TO: PCS Group Inc., Applicant
FROM: Julia Duncan, Associate Planner
DATE: January 24, 2022
SUBJECT: SUB21-073; Compark Village South Tract G Sketch Plan
SUB21-074; Compark Village South Tract G Preliminary Plan
Review Comments 01

COMPARK VILLAGE SOUTH SKETCH PLAN

Compark Village South
Tract A Preliminary
Plan

COMPARK VILLAGE SOUTH
LANDSCAPE PLANS AND
MASTER STREET TREE PLANS

1 Deciduous Tree Planting Detail
Scale: NTS

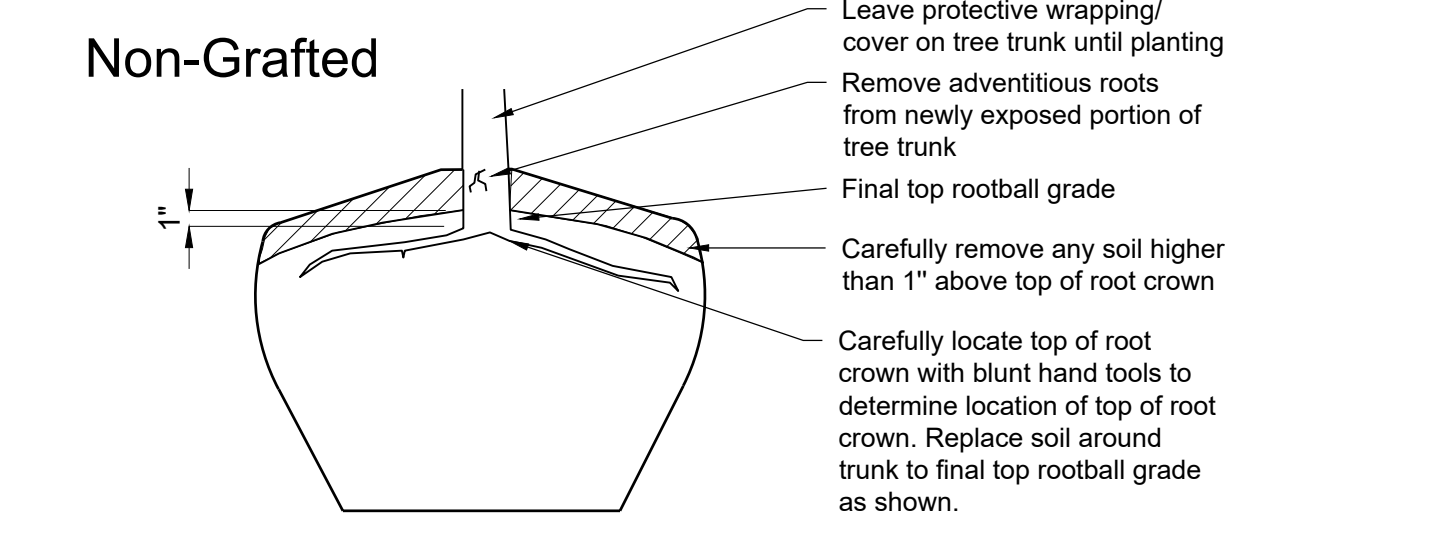
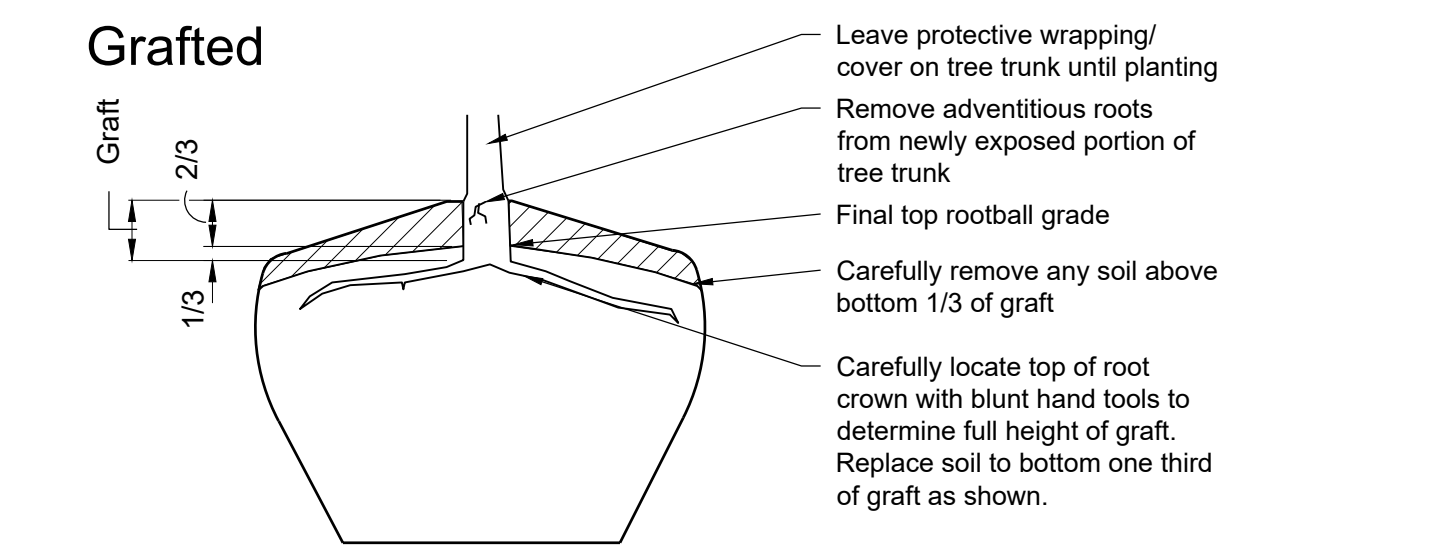
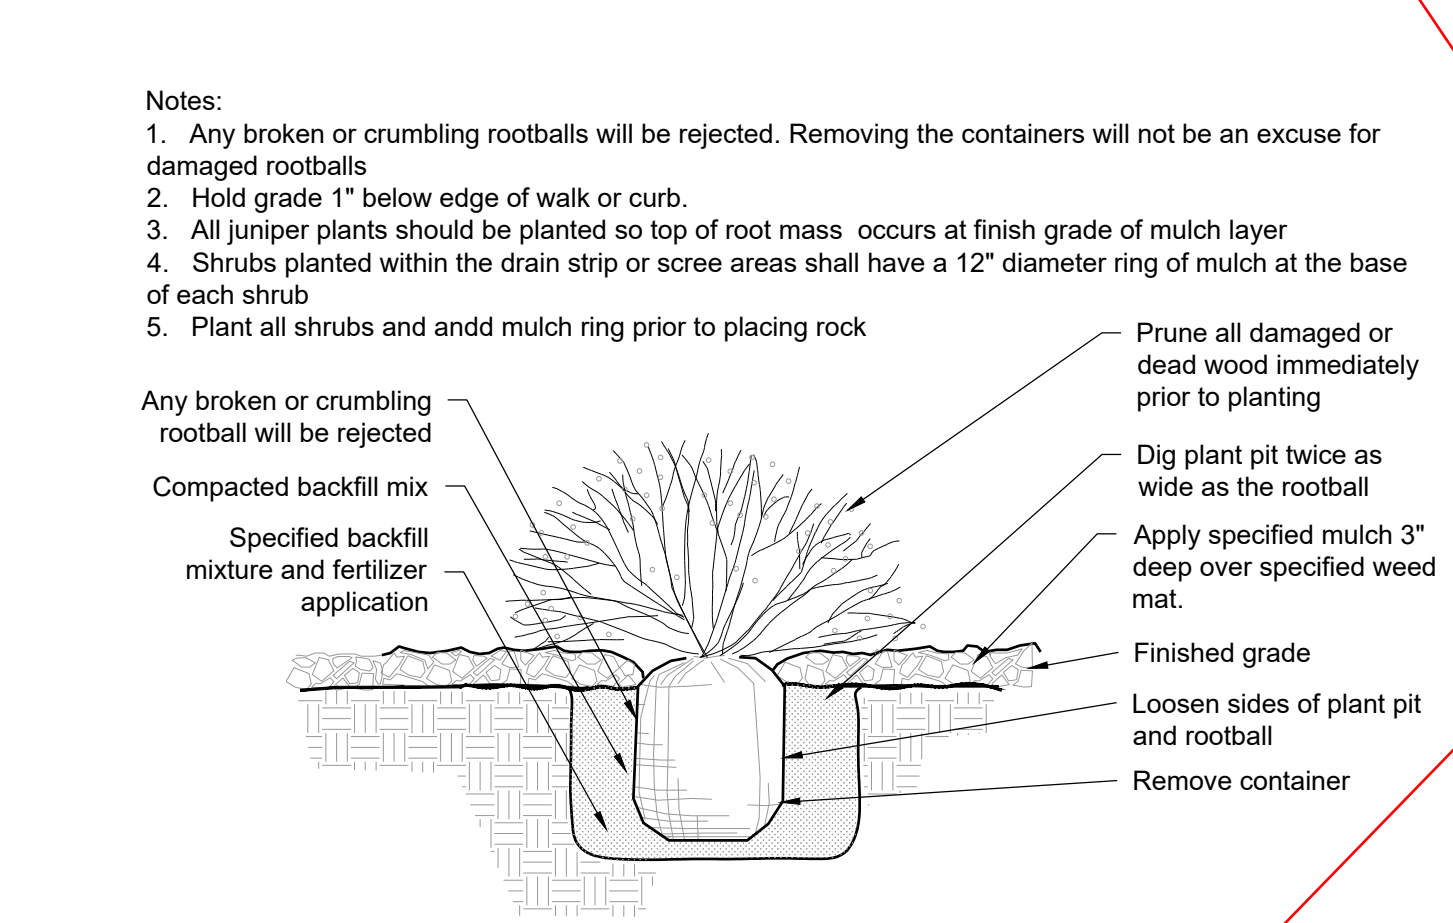
Must use Parker planting standards:
<http://www.parkeronline.org/DocumentCenter/View/400/Construction-Specifications?bidid>

Need to include a chart of linear street frontage of all streets and show breakdown of 1 tree per 40 linear feet. The requested tree totals need to show compliance with this requirements

Need to include a chart to show tree totals, shrub totals, and grass totals

provide percentage to required landscape area

Sheet Name
LANDSCAPE AREA 3
Sheet Number

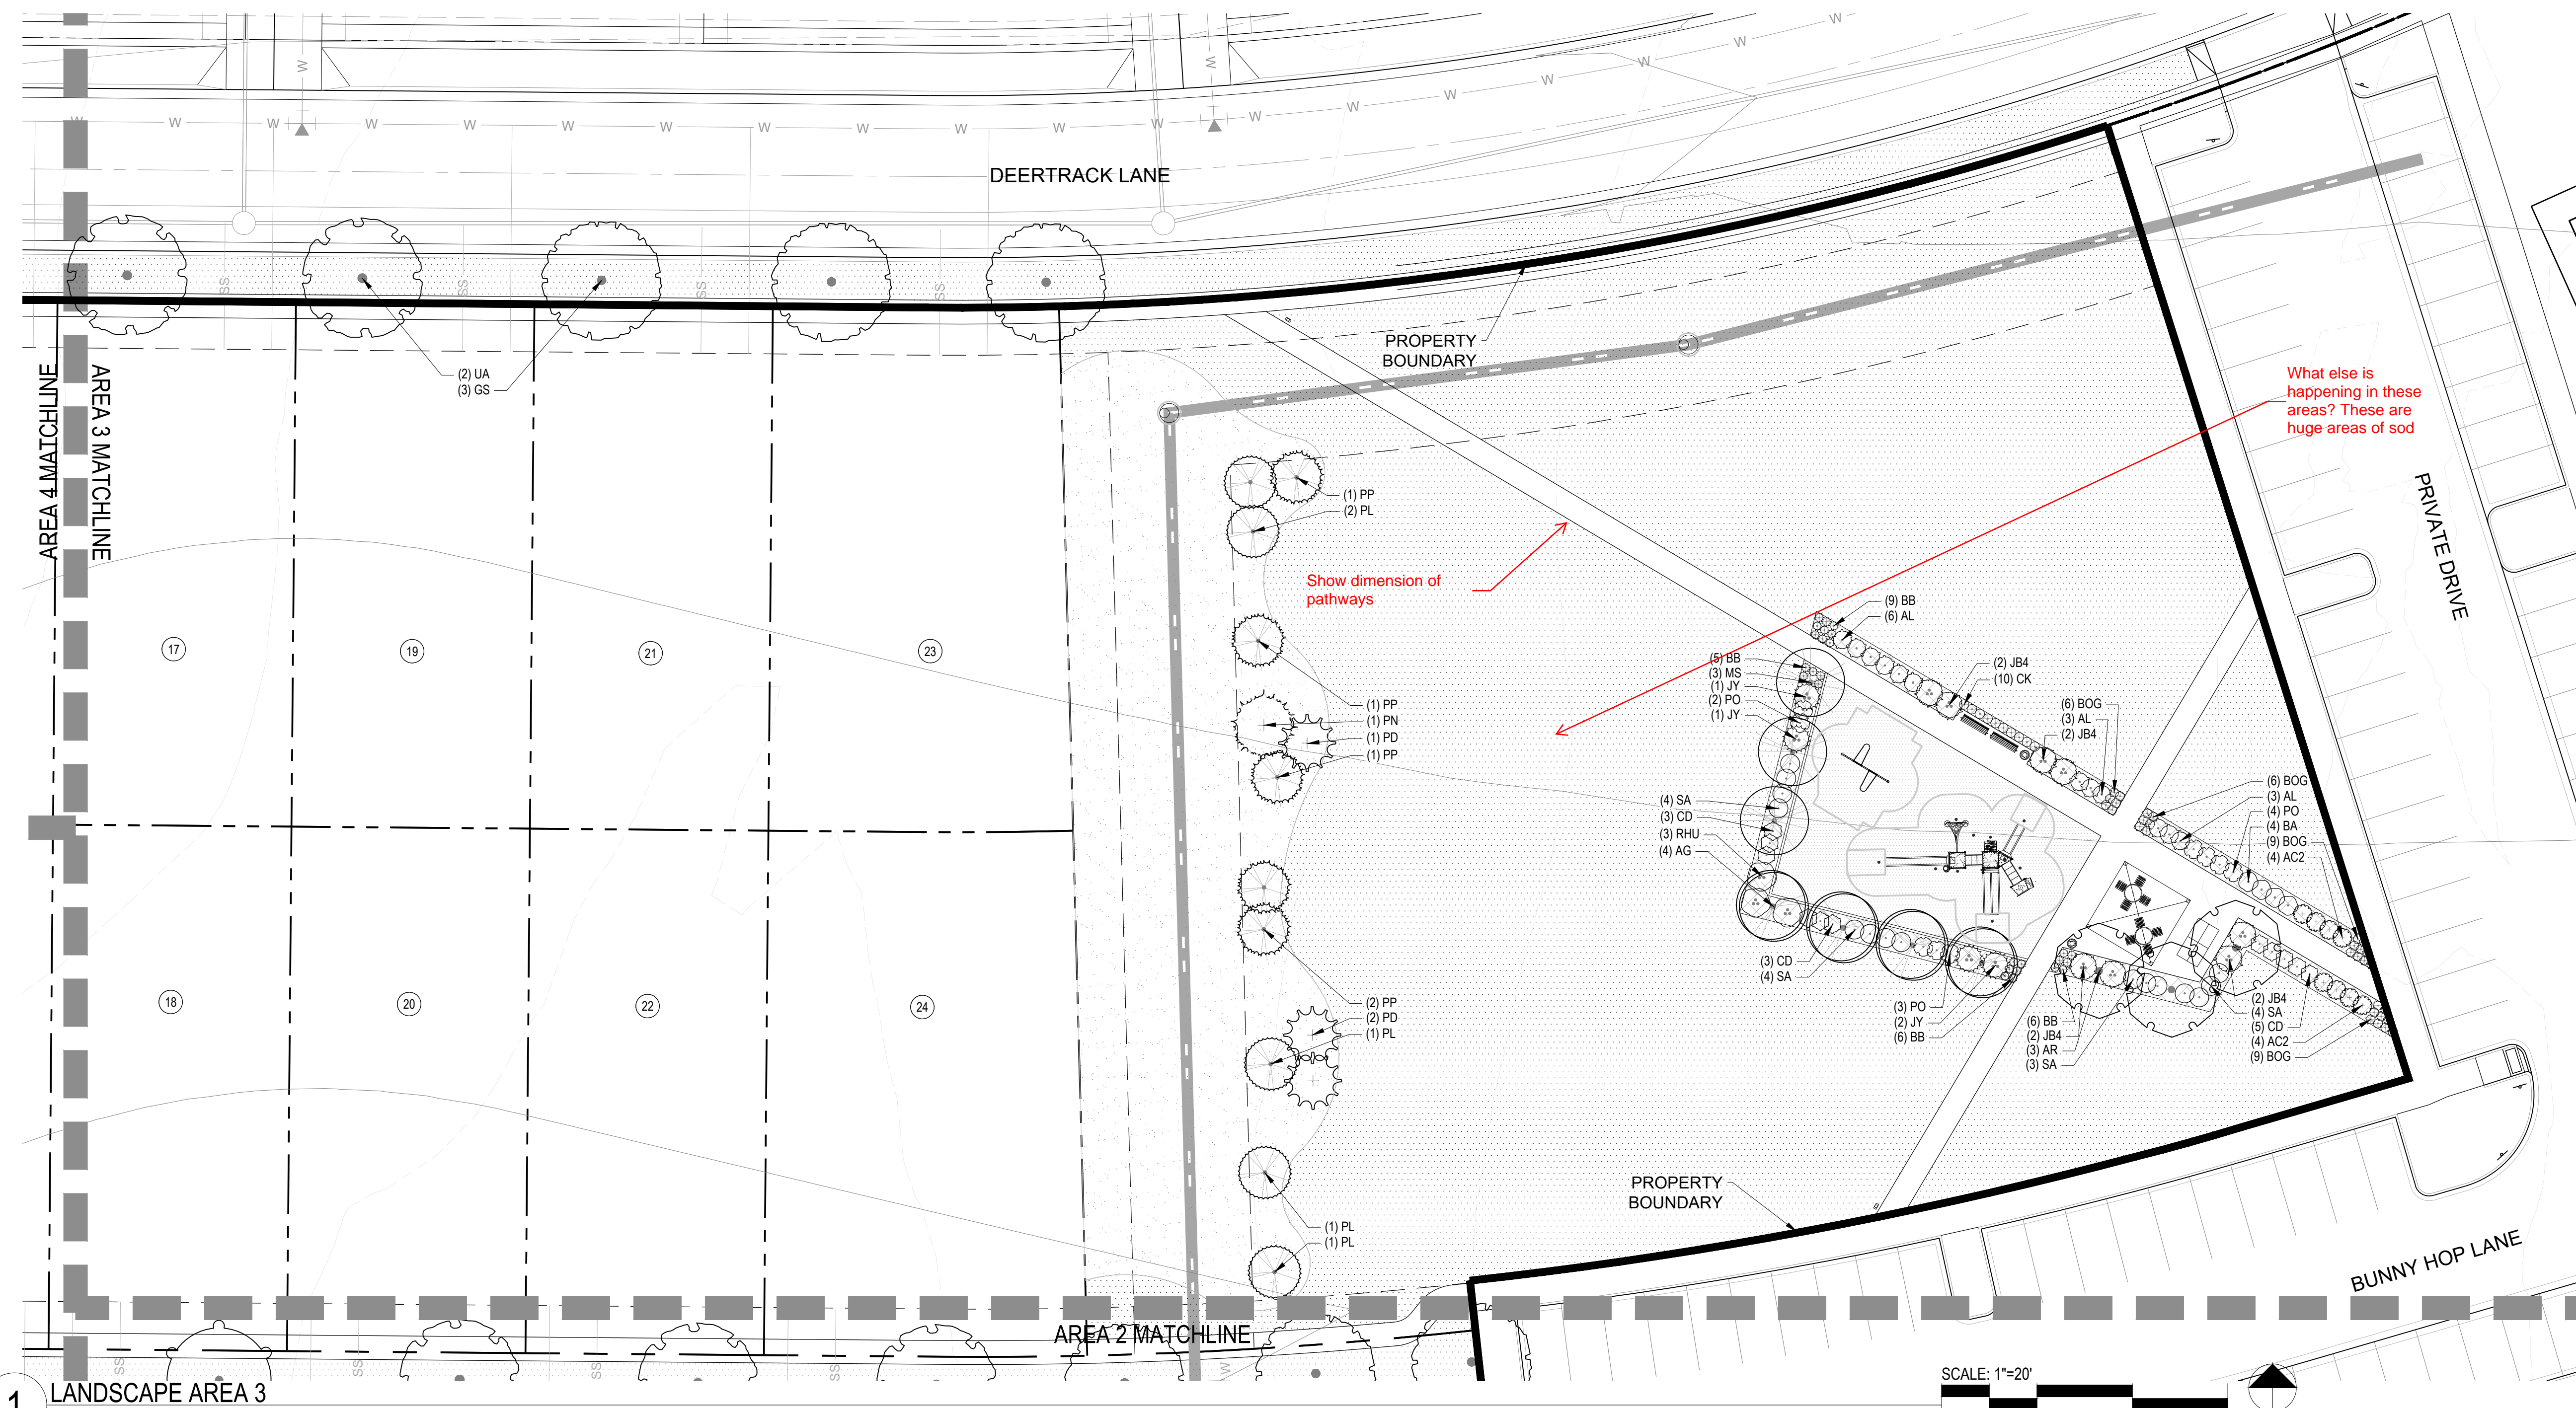
What else is happening in these areas? These are huge areas of sod

Show dimension of pathways

Sheet Name
COVER SHEET
Sheet Number

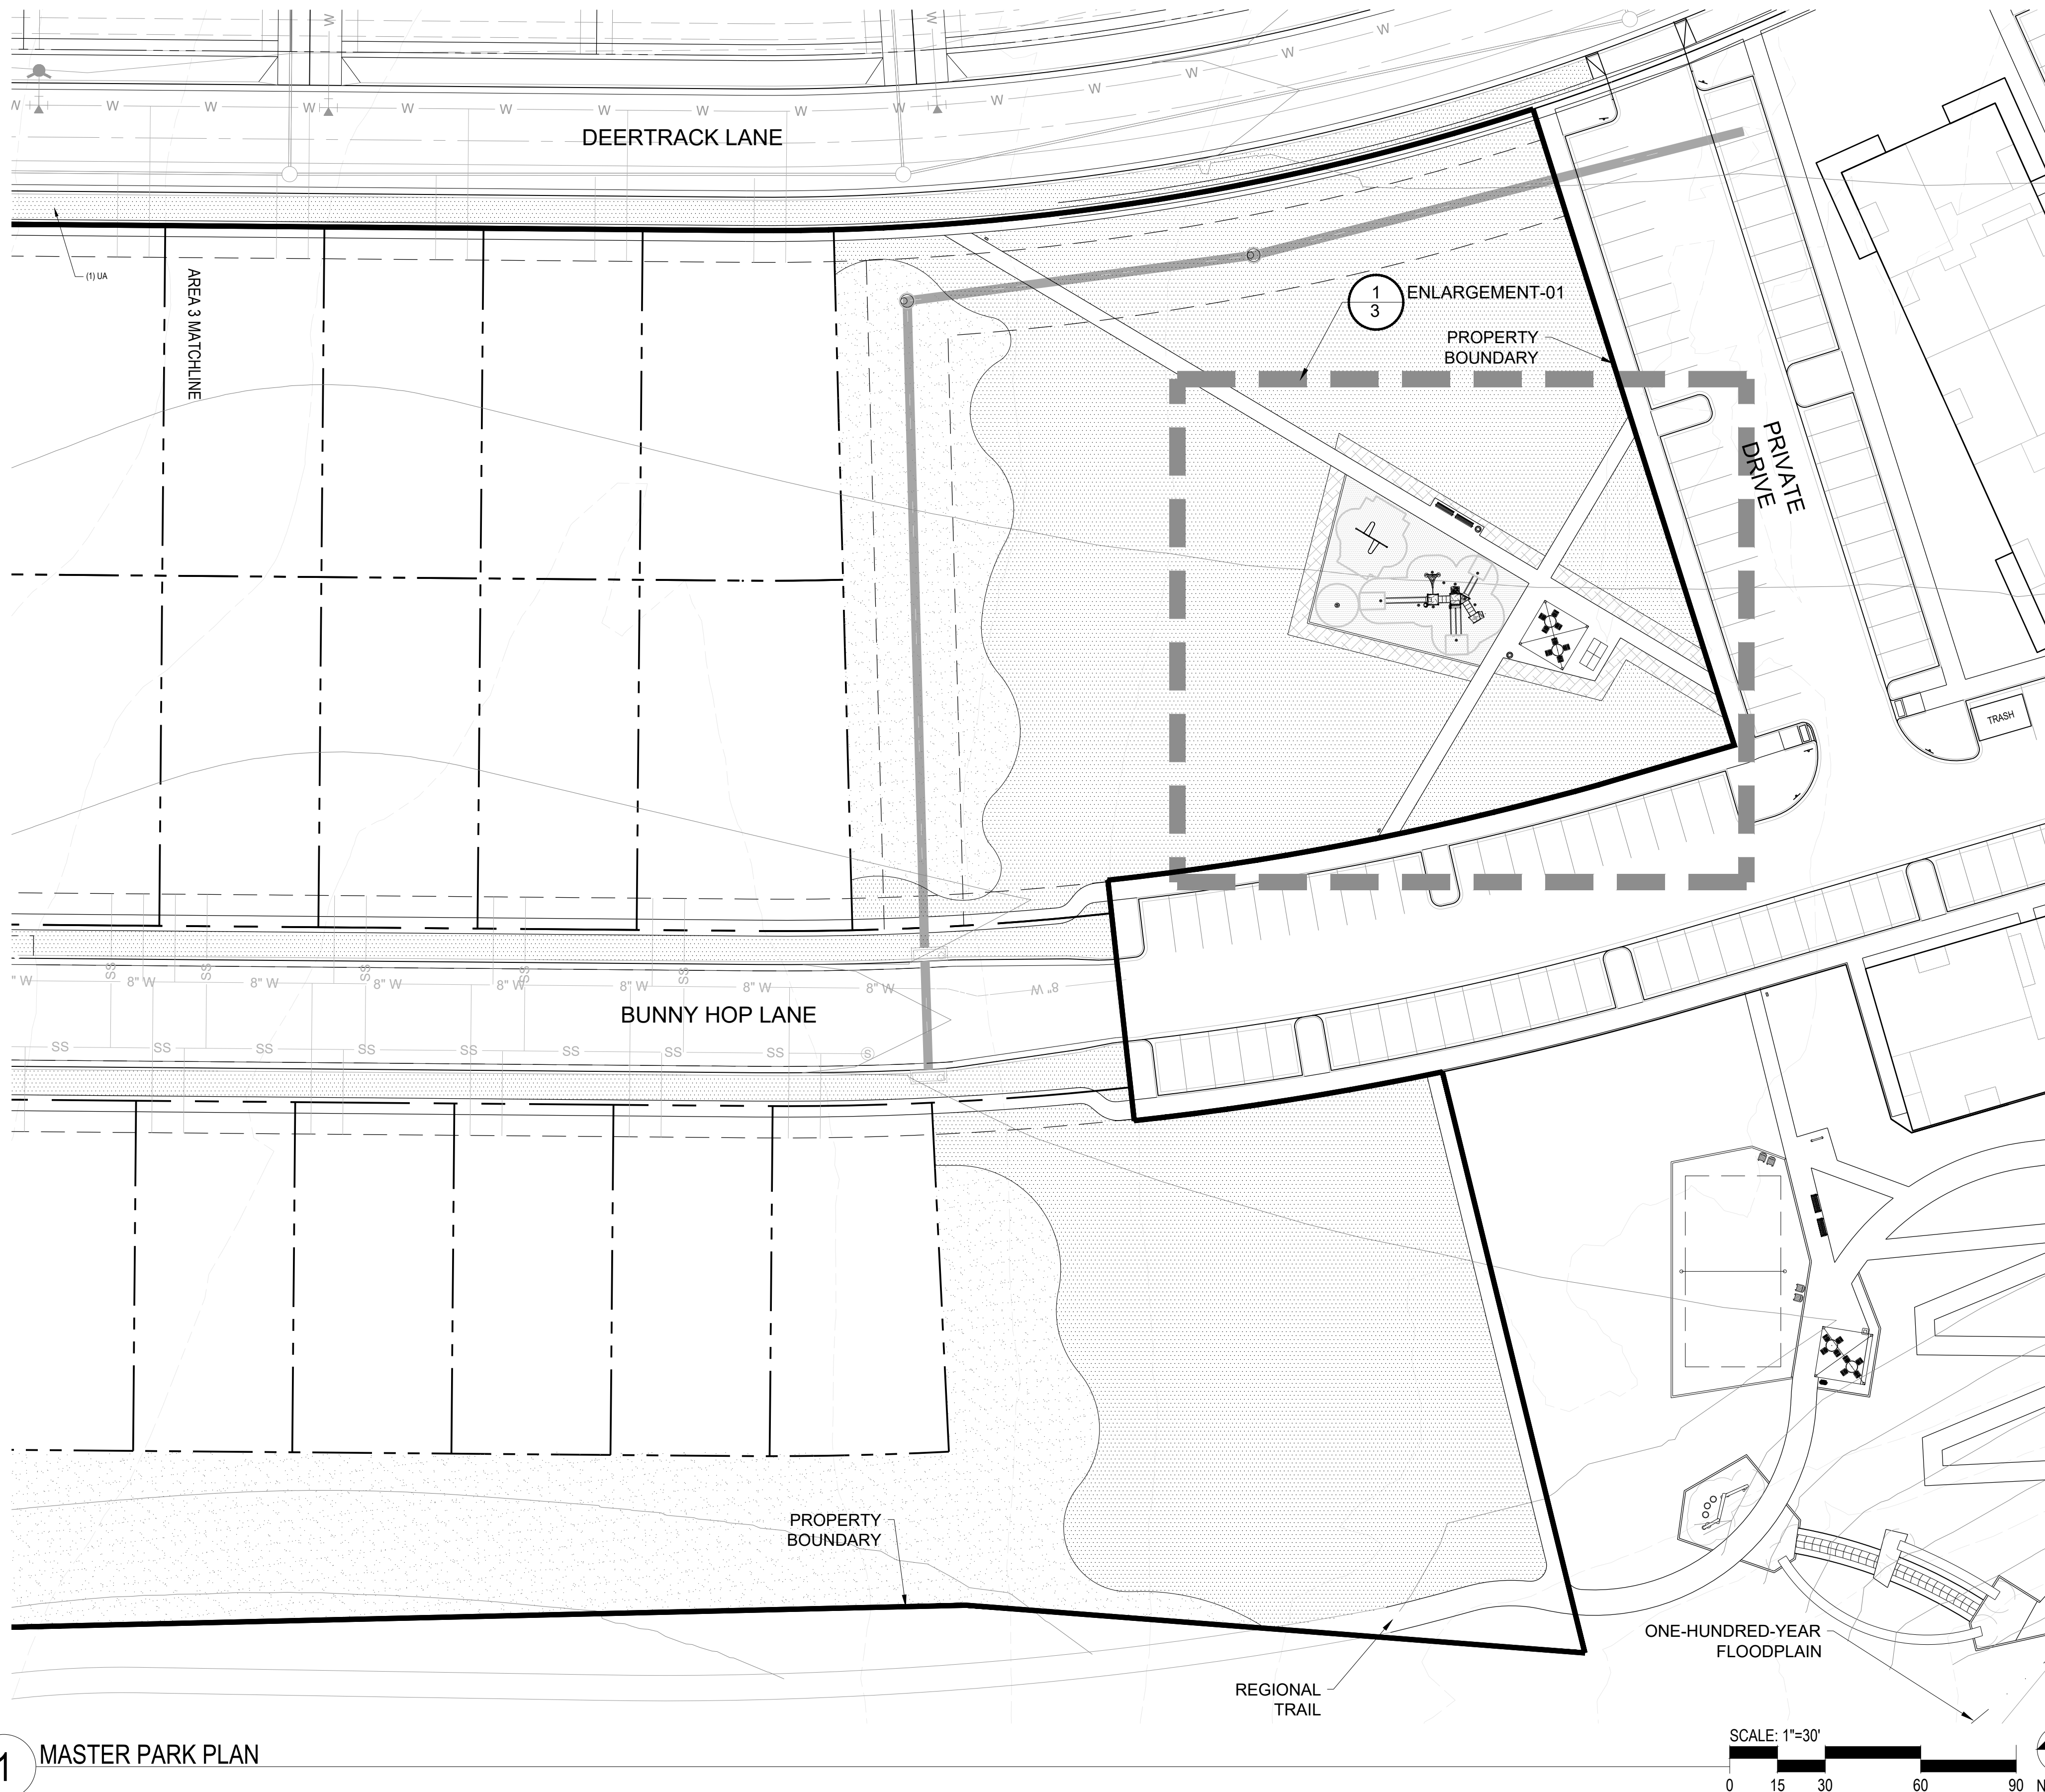
Need to include irrigation plan

Include Park acreages/sf in chart
